Horowhenua County Council

PERMIT No. 15880
C024145LOCALITY Waikanae

APPLICATION FOR BUILDING PERMIT

Particulars of Building: Foundations: concrete Walls: timber Roof: tileTotal floor area: 231 m² 237 sq. metres. front = 16.6 1st = 7.2 (garage = 3.6)2. Purpose for which every part of Building is to be used or occupied. (Describing separately each part intended for use or occupation for a separate purpose) Garage room, double garage, 3 bedrooms, living room, dining room, family room, kitchen, bathroom3. Allotment: 460 m²Lot: 2D.P.: 55 724Section: 35-663Area: 460 m²Block: WALKWAYS.D. WALKWAYLocality: Edge water ST4. Owner's Full Name: NICHOLAS HENRY BRANLEYAddress: P.O. Box 365 Parua

APPROVED
DATE

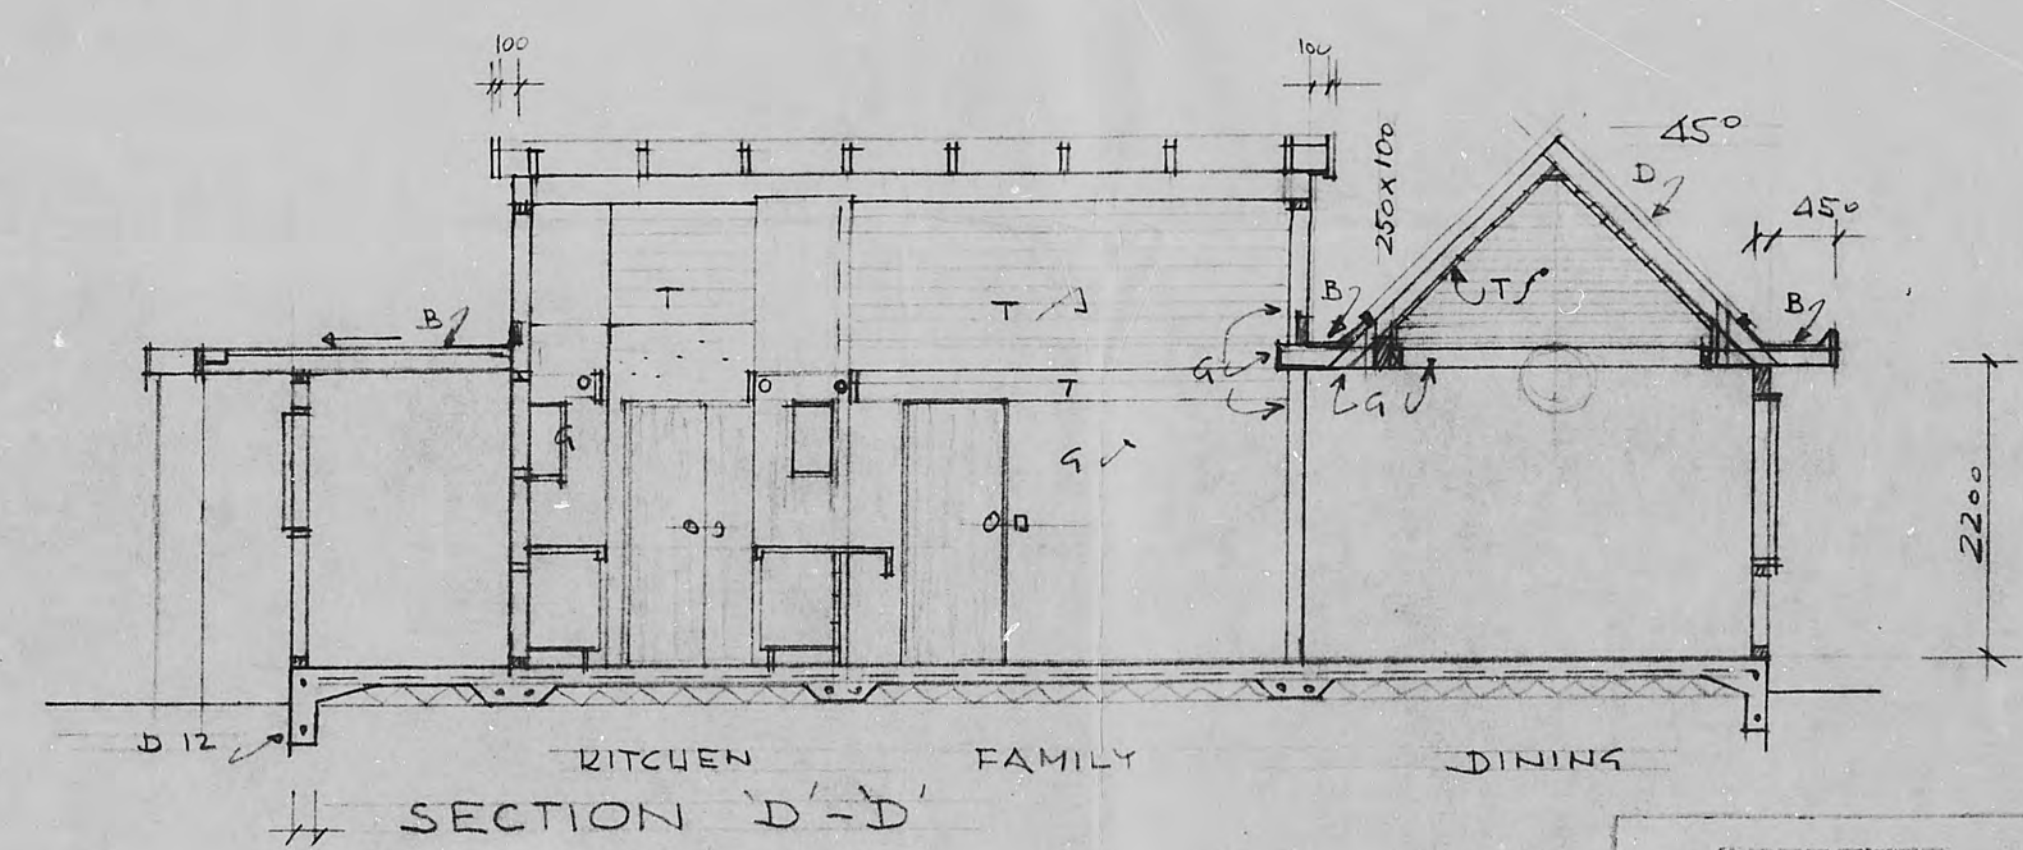
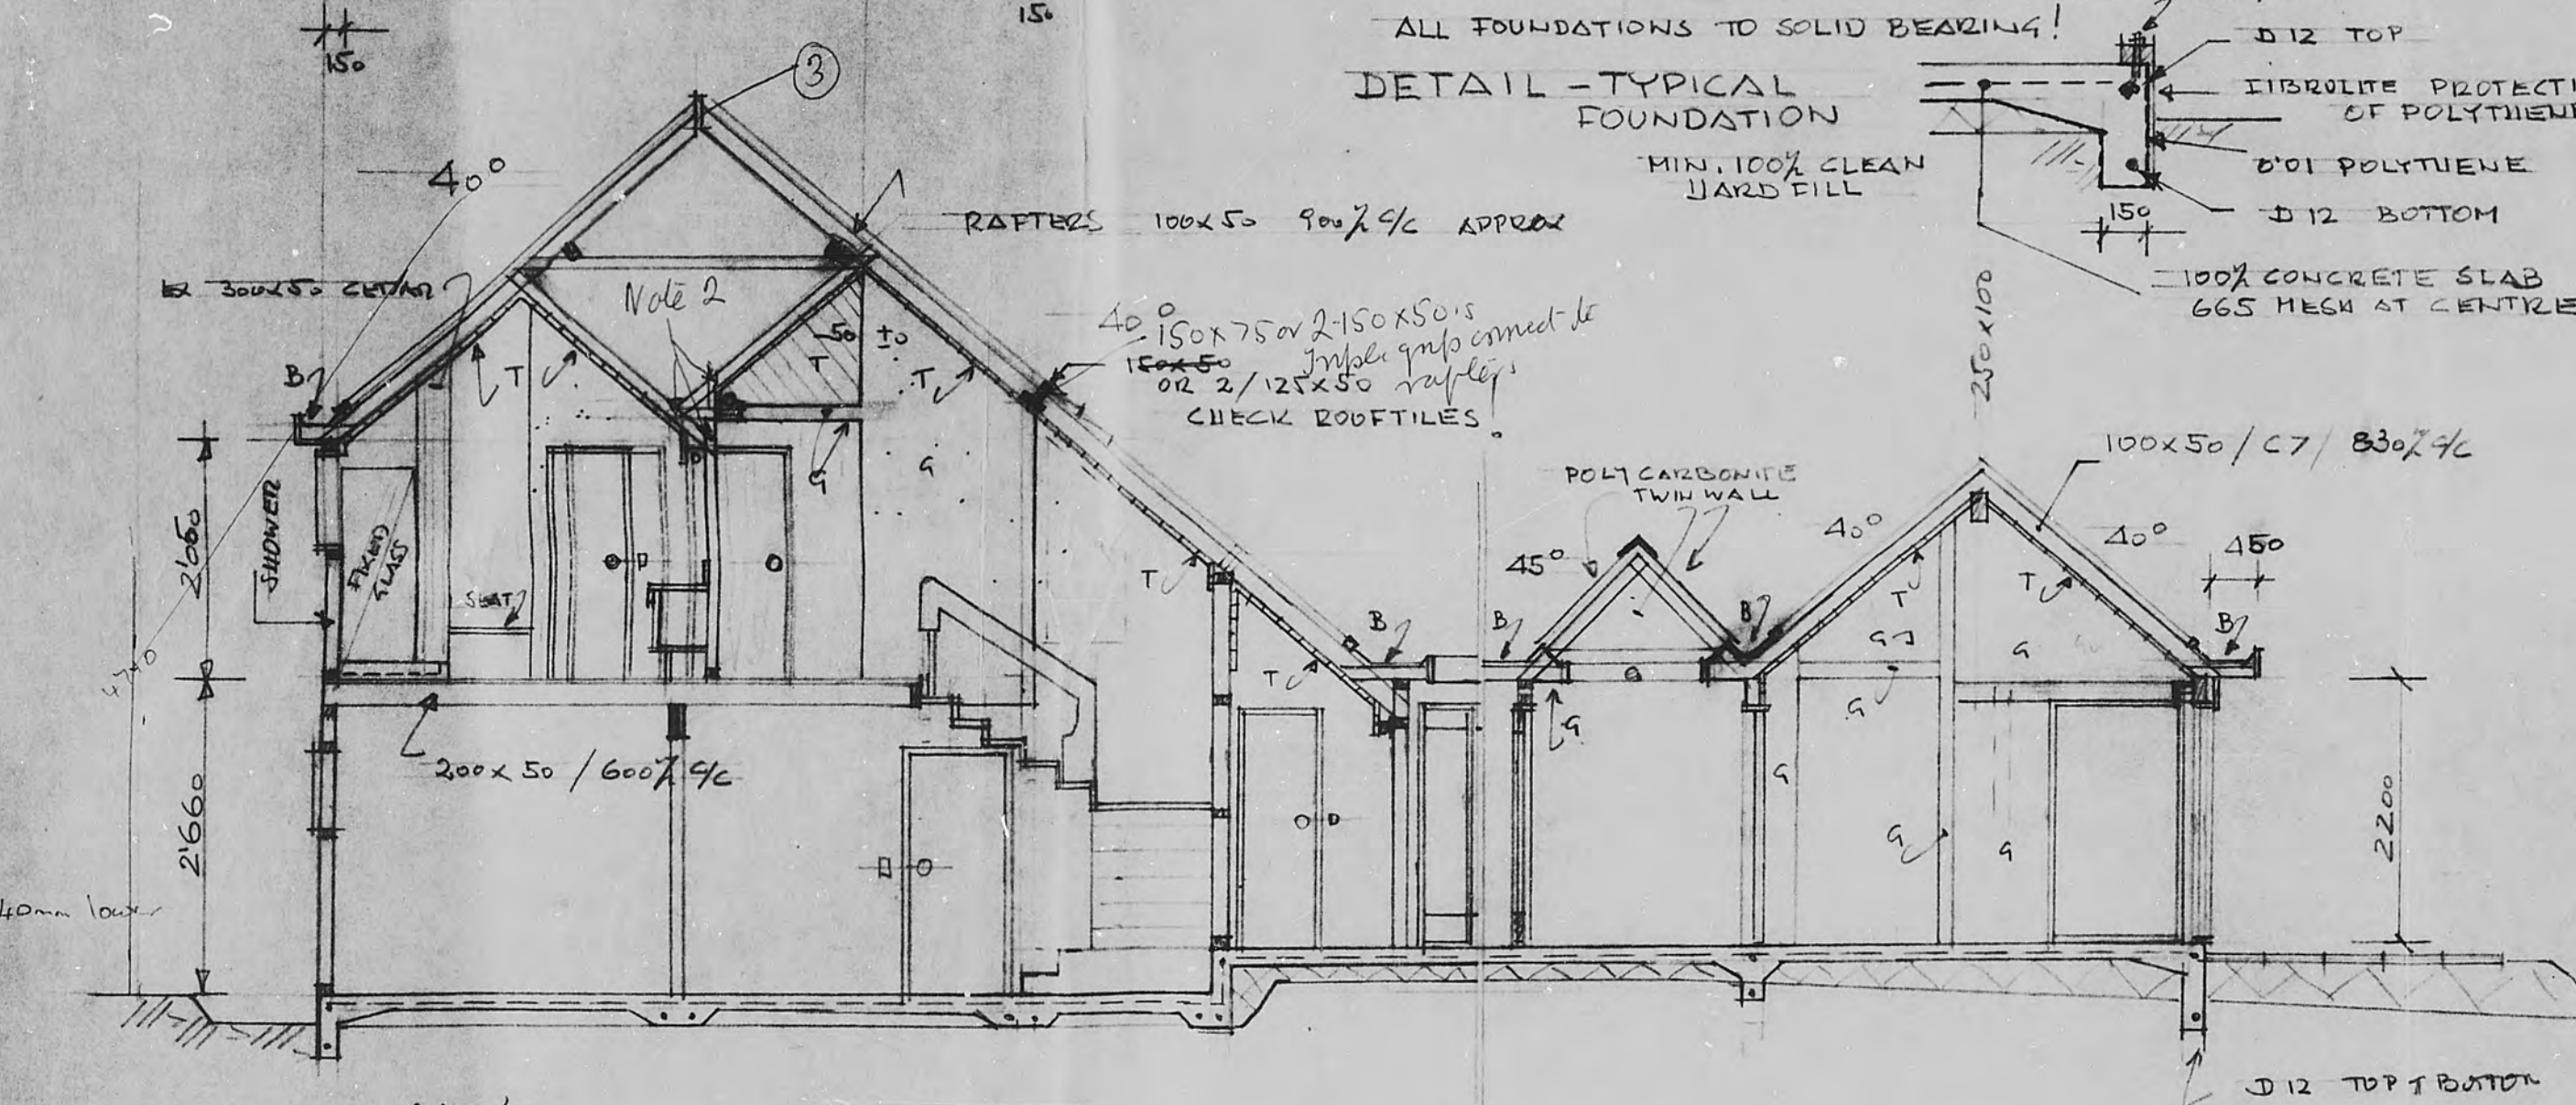
- Notes
- Foundation to HCC detail S/309A. Reinforce foundation to the storey area to have 200mm wide footings (X 150mm thick) with reinforcement and R 4 ties as required by NZS 3604 cl 4.6.4 and cl 4.6.4.6
 - Provide pair of 4N (mm) nail plates to each post embedded on section B-B
 - Min size of ridge in this area would be 150x25
 - Strap head and secure foot of rafters (to roof area supporting sloping ceilings) as required by NZS 3604 cl 6.6.1.5 and 6.6.1.6
 - Where limits exceed 2.7m clear span it will be necessary to strap rafters to double studs and double studs to sub floor framing as required by NZS 3604 cl 6.6.1.5 + 6.6.1.6
 - Ridge beam over kitchen to be supported on wall in the region of the oven.

Roof Beam Size over lounge

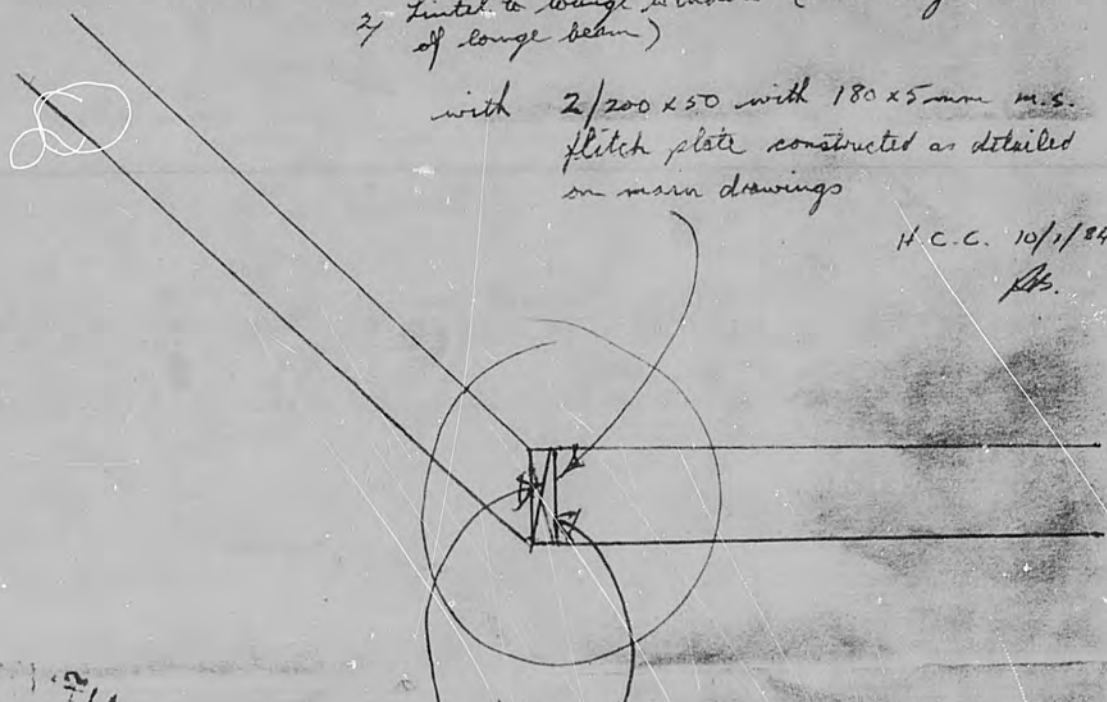
(a) roof span over lounge = 2.5m for 3.0m over lounge
≈ 3.0m for rest of 5.8m span
⇒ distributed area = $\frac{2.75}{2} = 1.37m$

$$M = \frac{W L^2}{8} = \frac{1.17 \times 5.8^2}{8} = 4.92 \text{ kNm}$$

$$f_b = \frac{M}{Z} = \frac{4.92 \times 10^6}{58.9 \times 10^4} = 8.35 \text{ mPa} \text{ too high}$$

⇒ require pitched Beam:

⇒ Pitch Beam 2/200x50 timber beam plus 1/180x5mm plate to be constructed as to other beam detail
Norm H.C.C.

2/ Where the cantilever joists occur over the front of the garage, 200x50 at 275 c/c will be used.

3/ In section 'B B' it shows pitched & flat roof meeting at framework but where this does not occur it will be beamed & triple gripped as shown below.

Provide: 1/ Beam over lounge
2/ Lintel to lounge window (loaded by one end of lounge beam)

with 2/200x50 with 180x5mm m.s. girth plate constructed as detailed on main drawings

2 Triple grips
Per ceiling rafter,
1 each side.
